# Technical Guidance Committee Meeting

## Minutes

Thursday, May 21, 2015

**Idaho Correctional Industries – Conference Room  
1301 N. Orchard, Suite 110  
Boise, Idaho**

Figure 4-31. In-trench sand filter accessing suitable soils through an unsuitable soil layer.

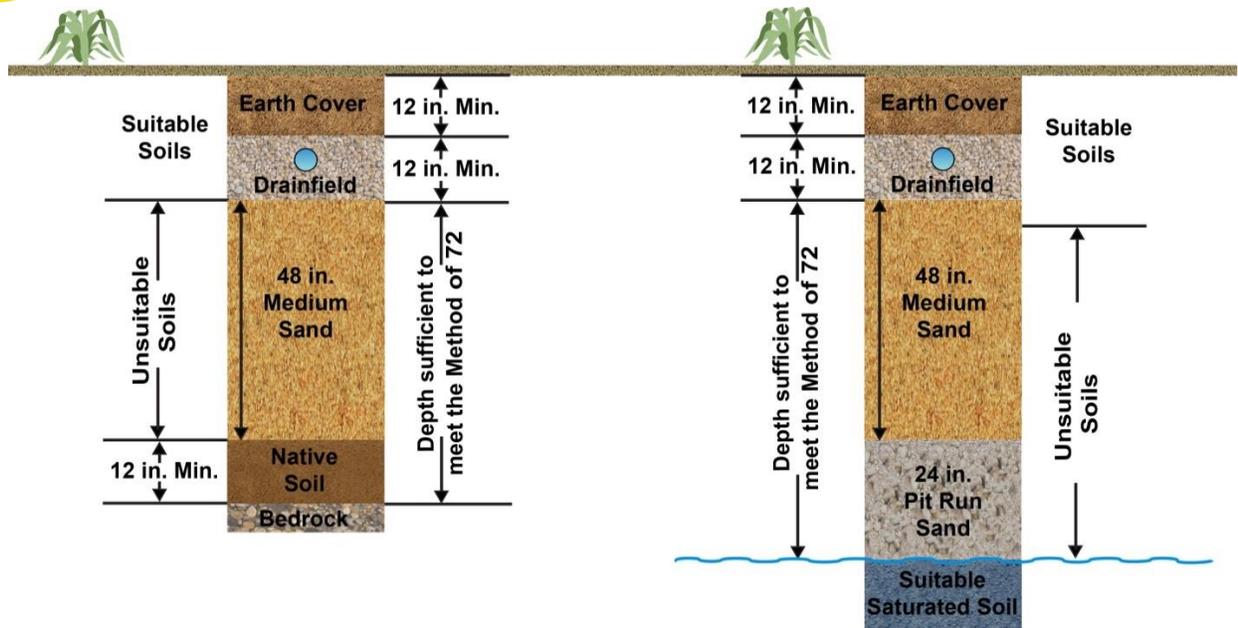
The committee held a discussion on the system equivalencies in relation to the system design. Tyler Fortunati stated that the standard in-trench sand filter depicted in figure 4-31 was consistent with the method of 72 and related standard system designs, the enveloped in-trench sand filter depicted in figure 4-32 was consistent with the method of 72 and related standard system designs, the enveloped in-trench sand filter depicted in figure 4-33 was consistent with separation distances for alternative pretreatment designs like the recirculating gravel filter, intermittent sand filter, etc. due to the requirement of pre-treatment preceding this drainfield design, and that the enveloped and pressurized in-trench sand filter shown in figure 4-34 was consistent with other pressurized filter designs like the intermittent sand filter and sand mound.

**Figure 4-32. Standard enveloped in-trench sand filter for installation in coarse native soils (i.e., coarse or very coarse sand or gravel).**

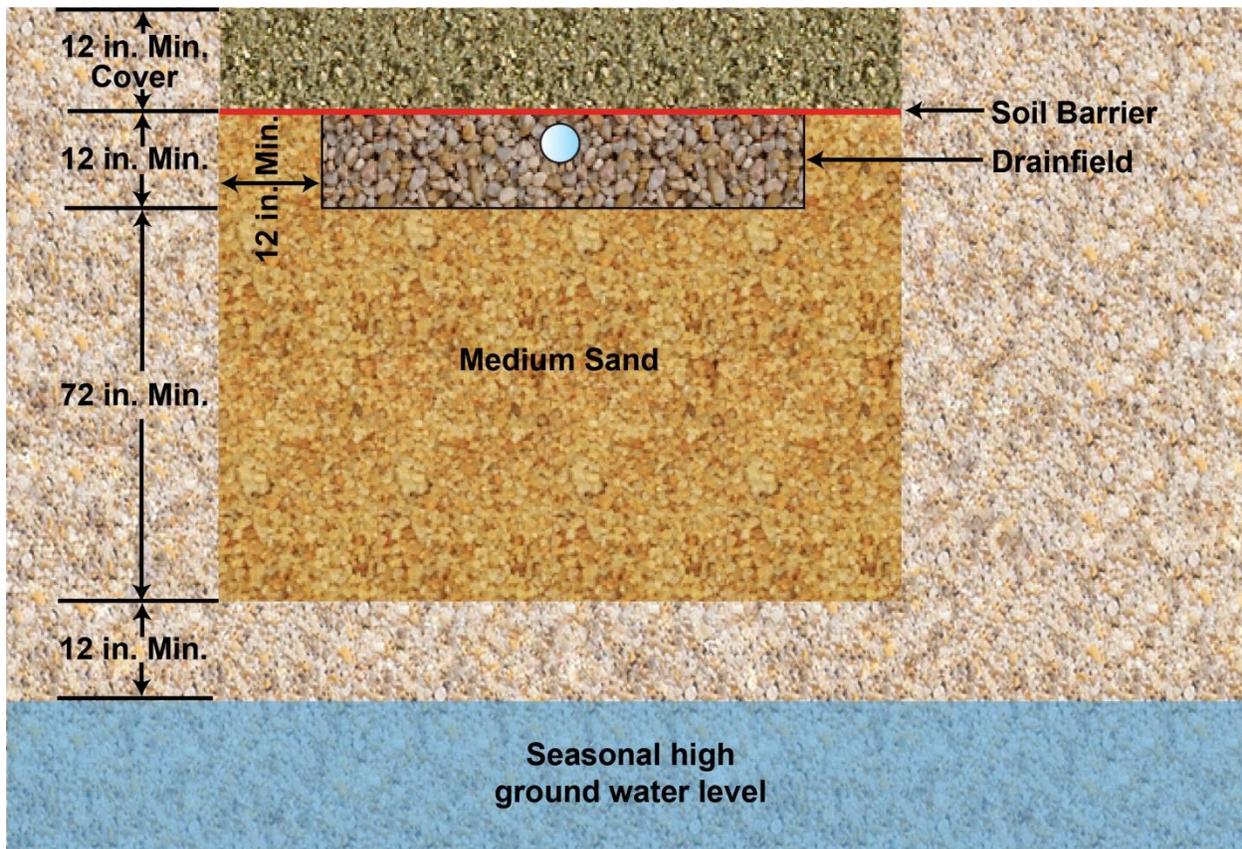
Dale Peck requested that a change be made to the enveloped in-trench sand filter designs for the application rate related to clay loam being less than the application rate for the clay loam instead of more than the application rate.

- 2) Unsuitable soils that have application rates less than clay loam as described in Table 2-9 are not suitable for installation of an enveloped in-trench sand filter.
- 3) The minimum depth of filter sand below the drainfield shall be 6 feet Figure 4-32.
- 4) The enveloped in-trench sand filter must maintain a minimum of 12 inches above any limiting layer from the bottom of the filter sand.
- 5) The drainfield shall be sized at 1.2 GPD/ft<sup>2</sup>.

Figure 2-4. Test hole profile used in example 2.

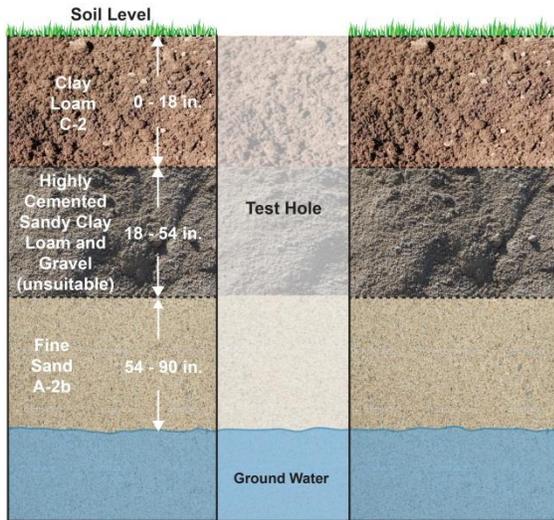
Bob Erickson requested that the statement in example 2 related to medium sand installation depth be moved up into the main guidance body in section 2.2.5.2.

**Figure 4-2. Cross-sectional view of an above-grade capping fill trench.**

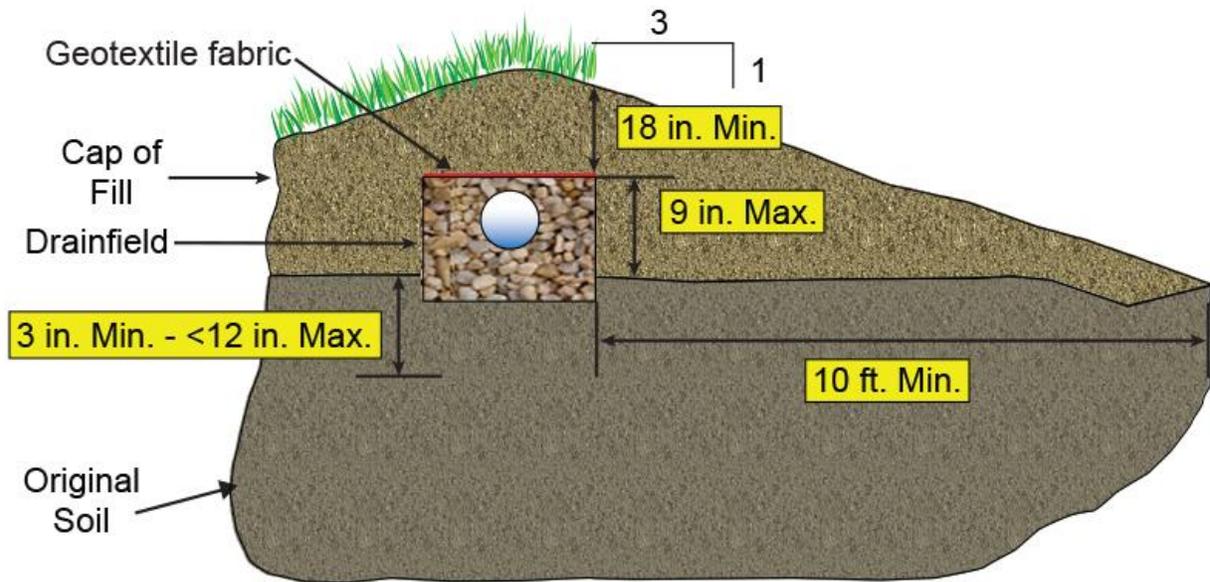
Mike Reno requested that a change be made to the construction requirements for the above-grade capping fill system that the soil cap must be constructed prior to system excavation when constructing with pipe and aggregate.
